Revisions: 27.04.23 RESPONSE TO RFI KW

Project: **BALFOUR PLACE**

Drawing: **BASEMENT COMPARATIVE PLANS**

Drawing No: **RFI - 01**

Drawing / LEVEL 3
COMPARATIVE PLANS

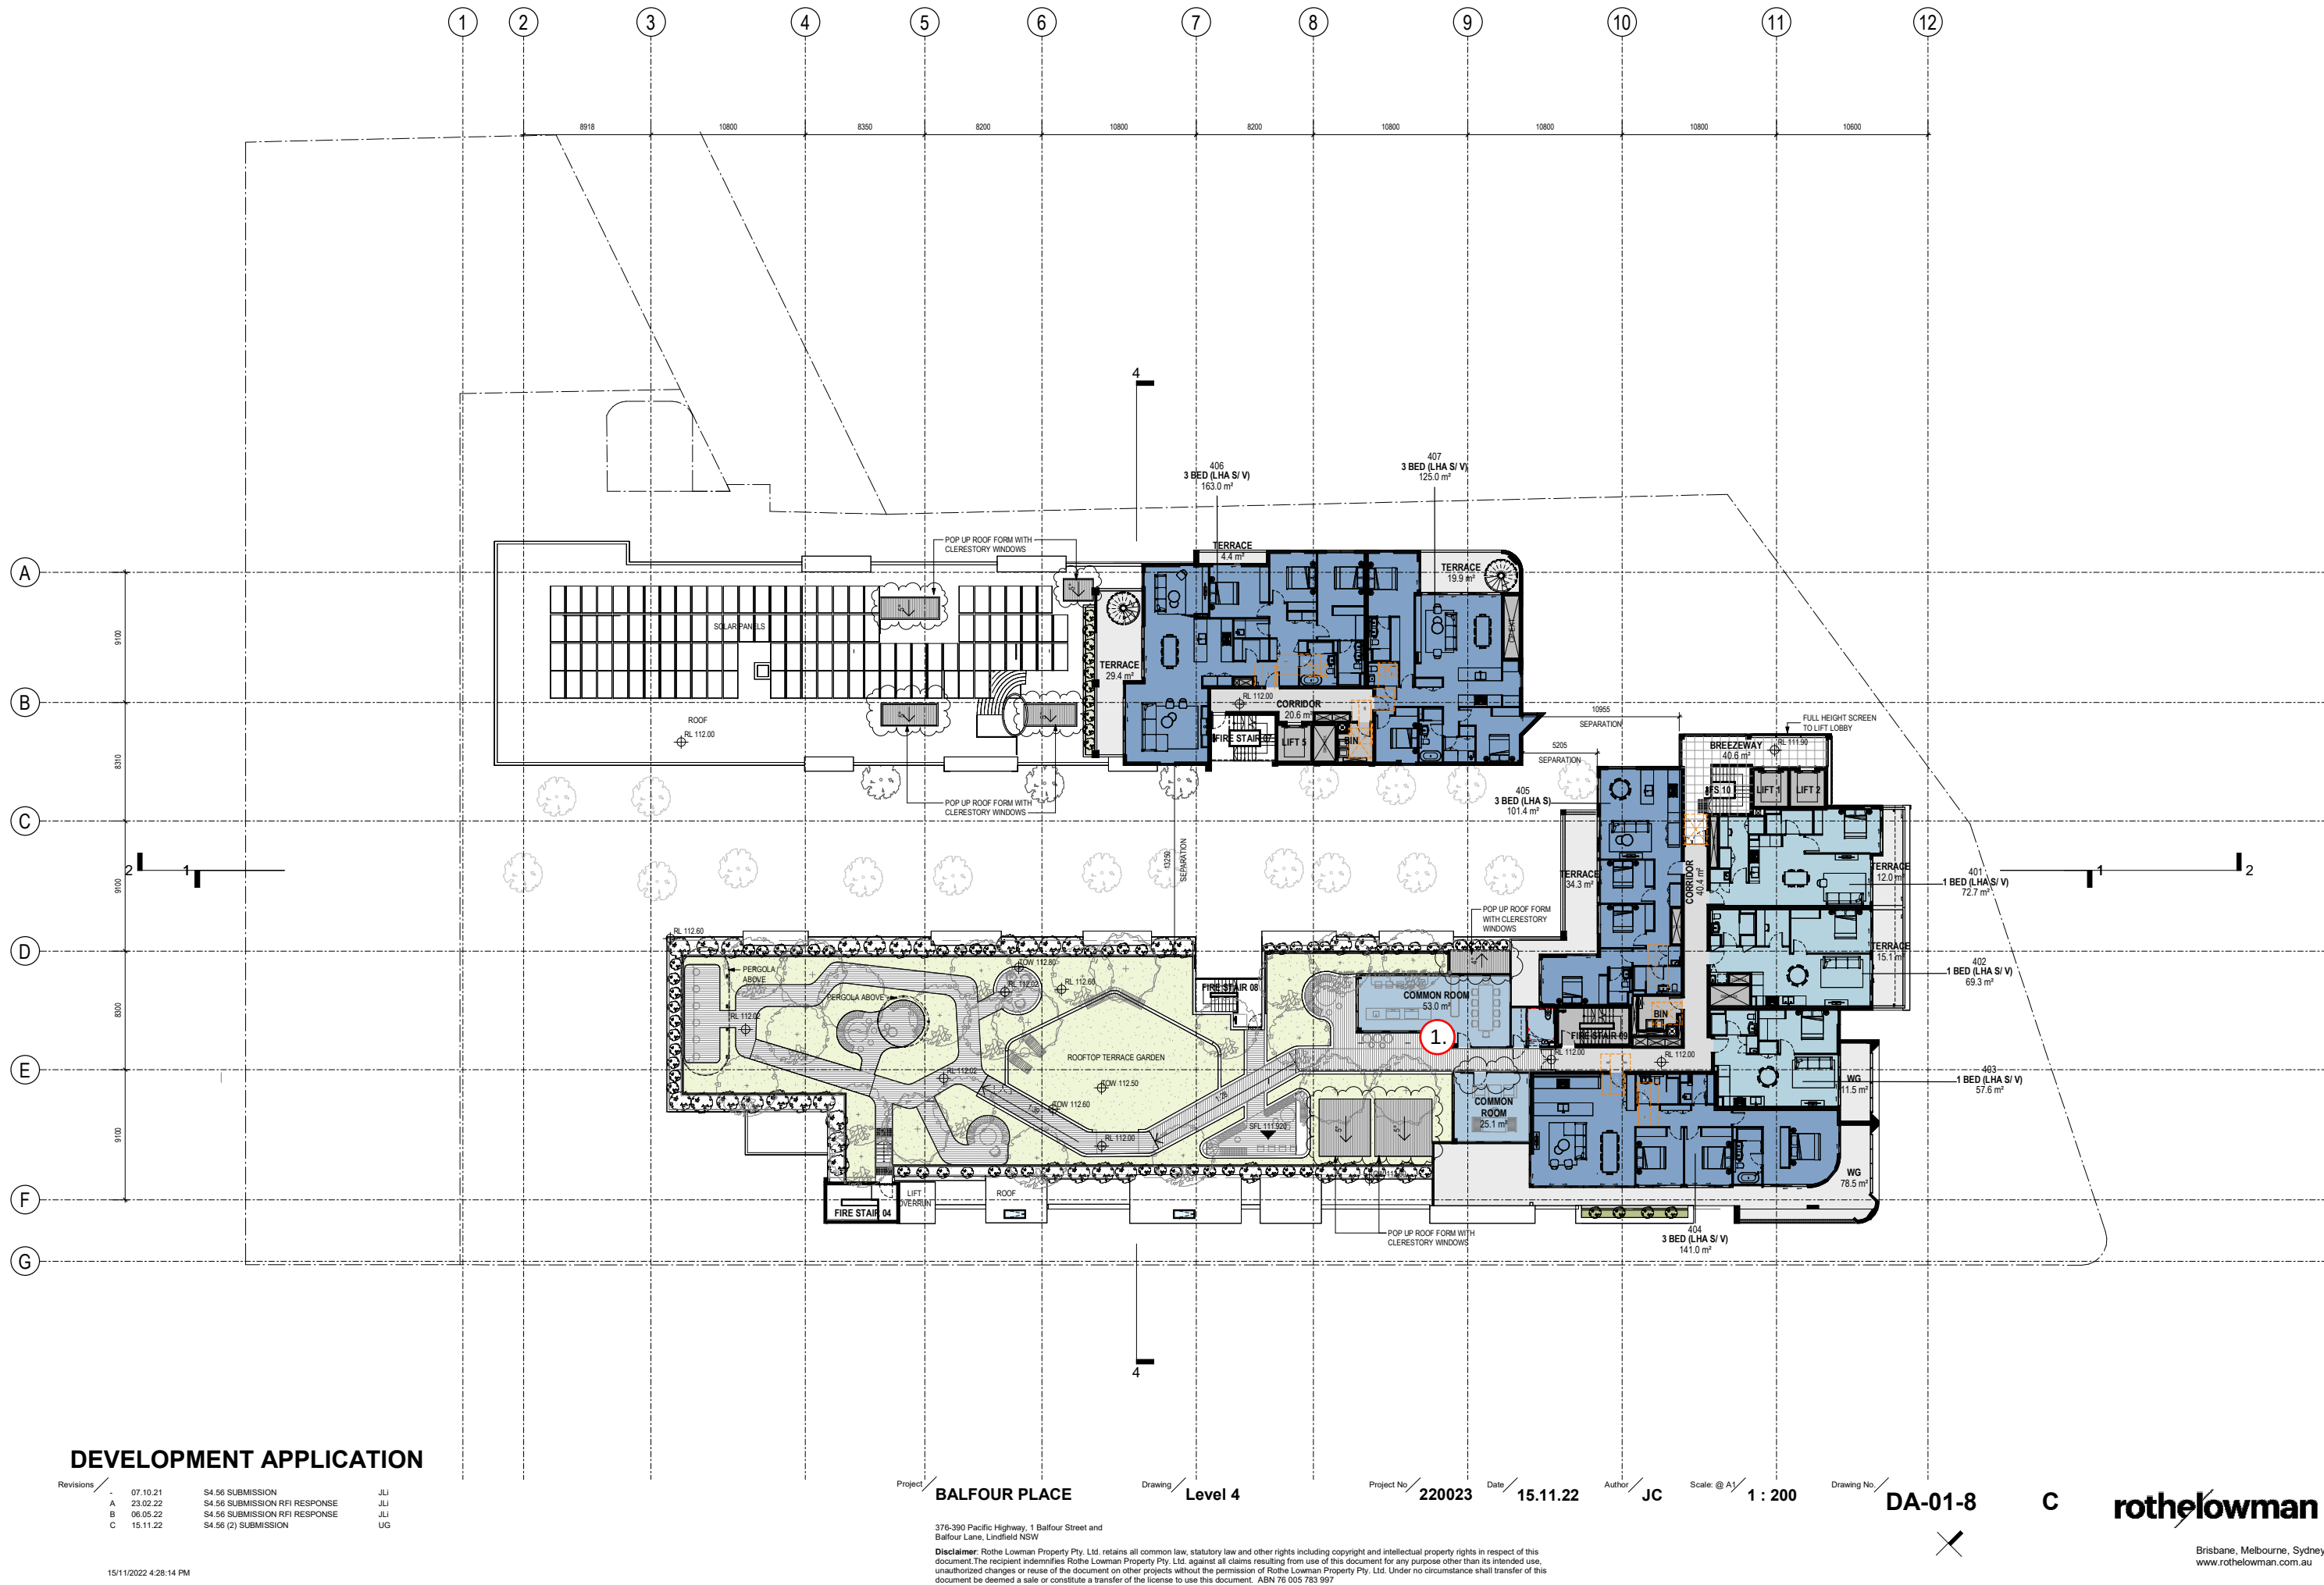
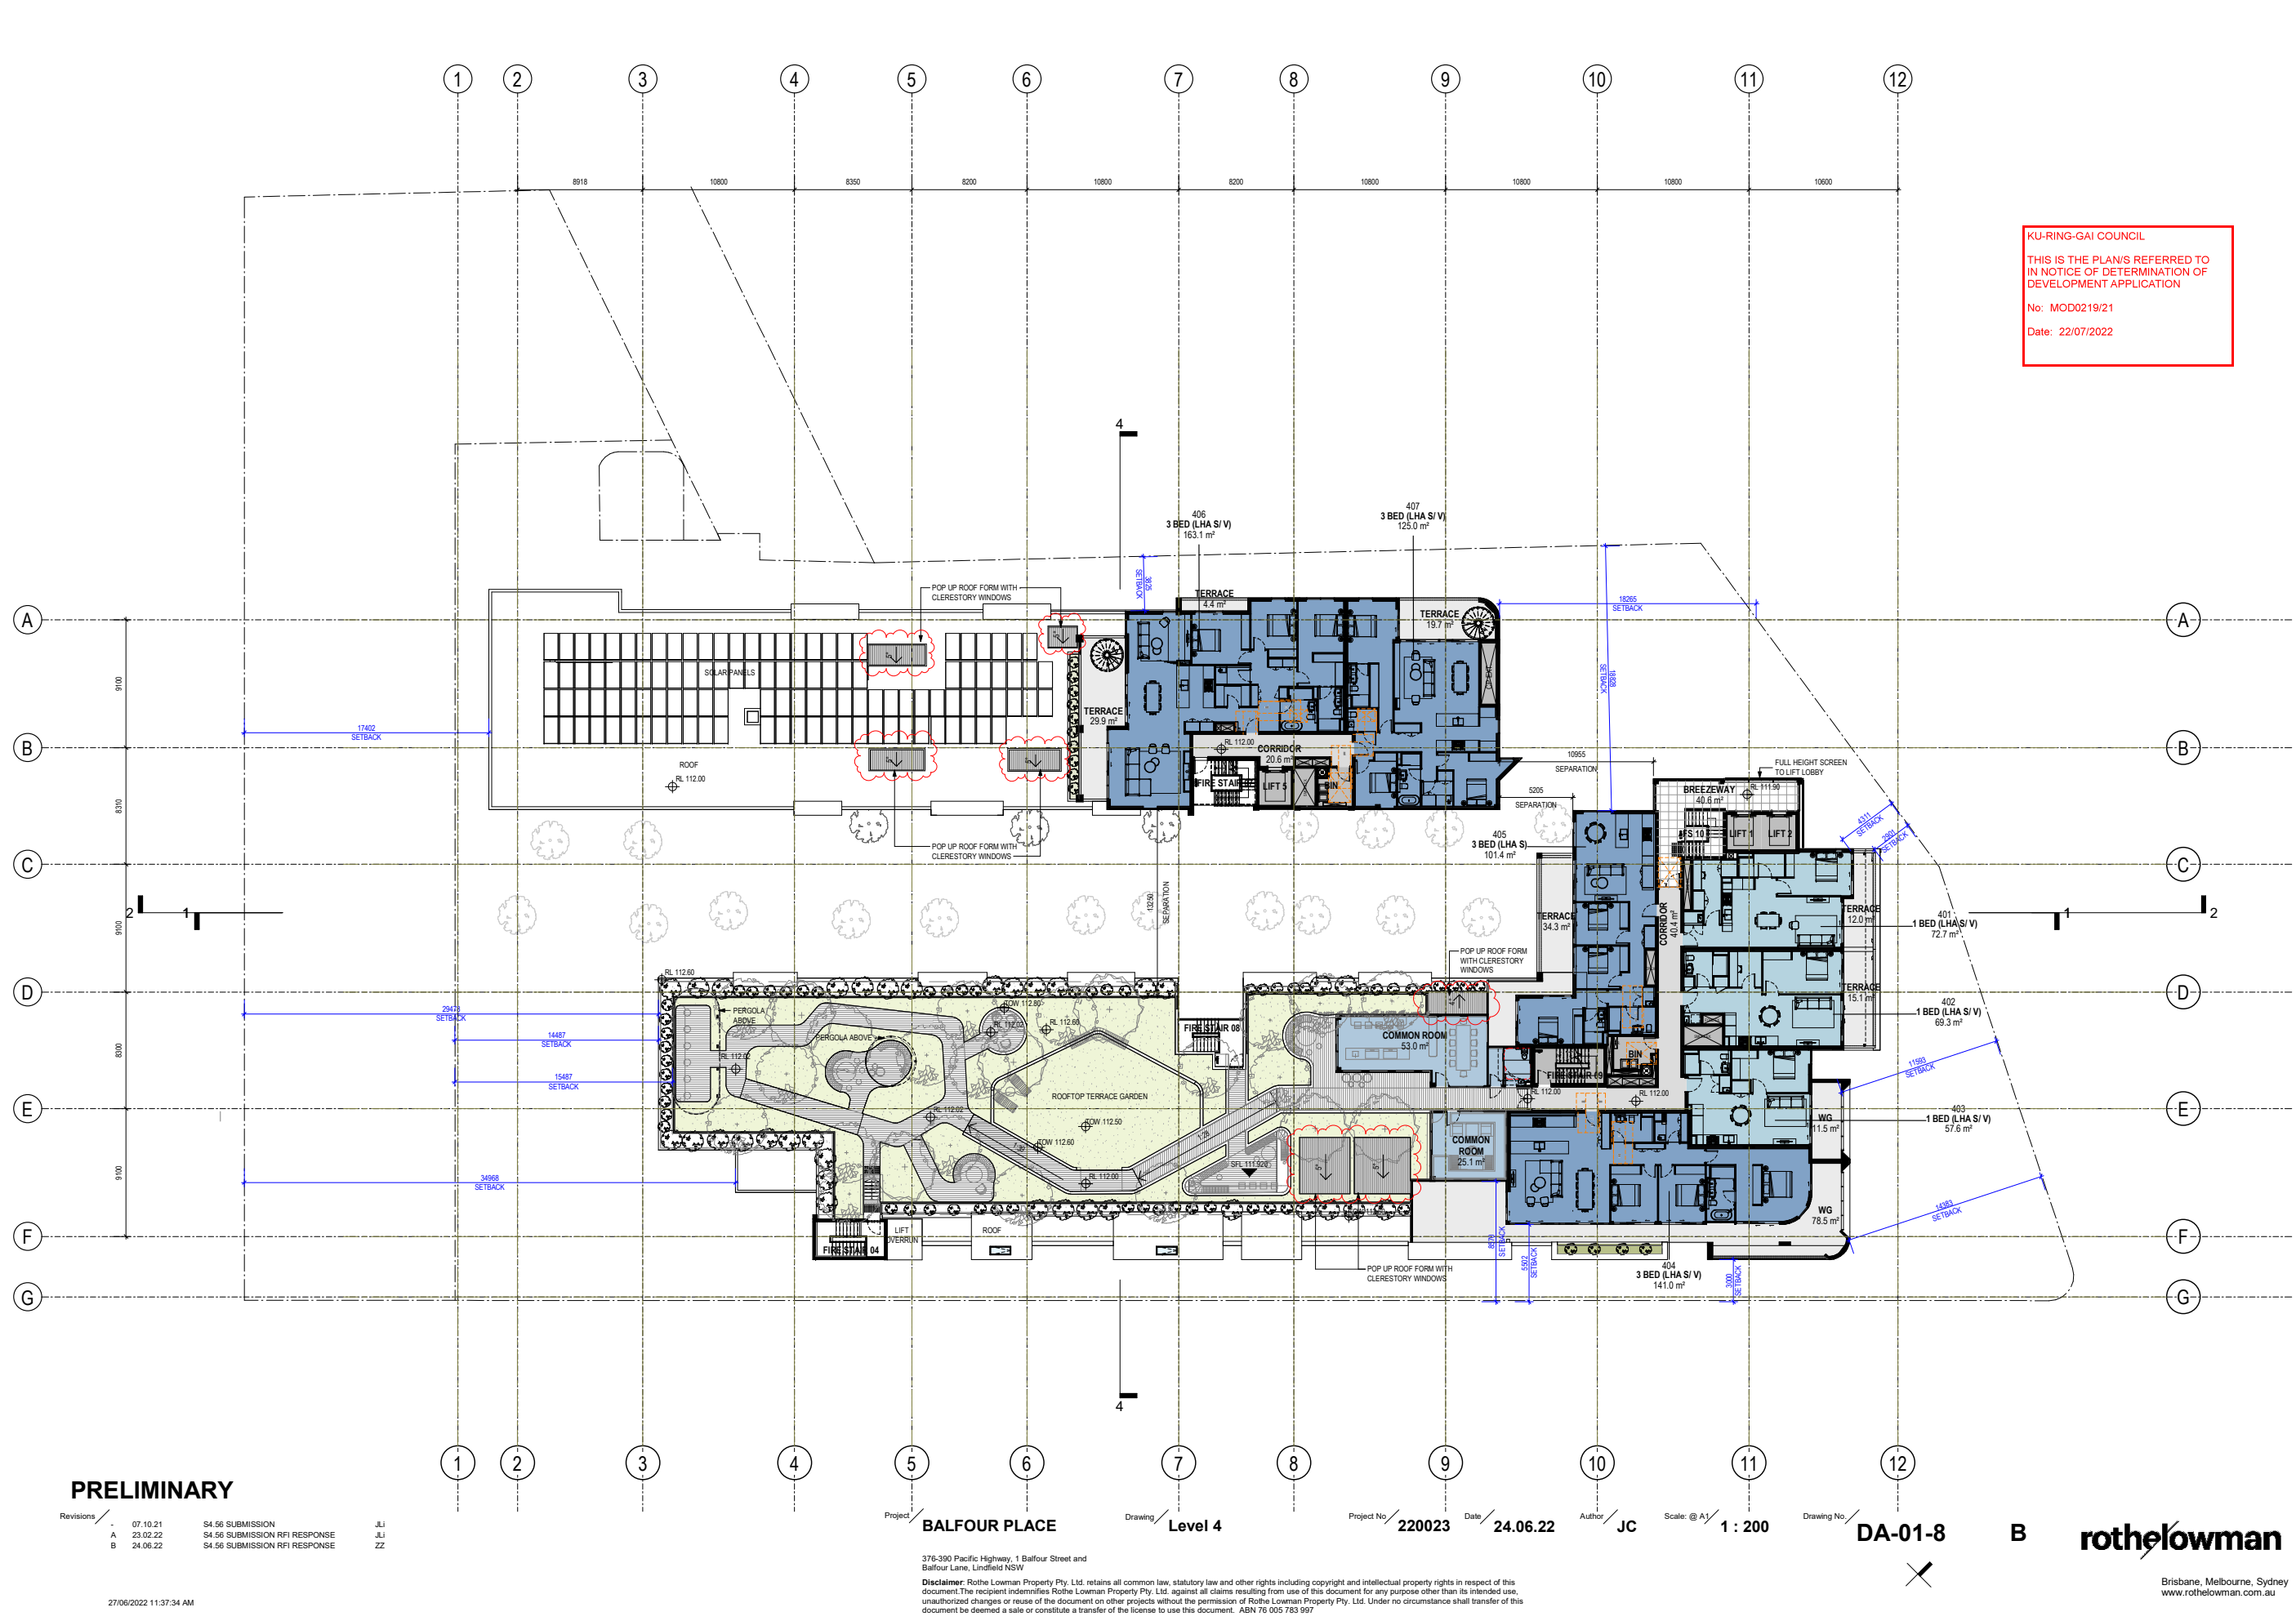
1. ADDITIONAL COLUMN FOR STRUCTURE
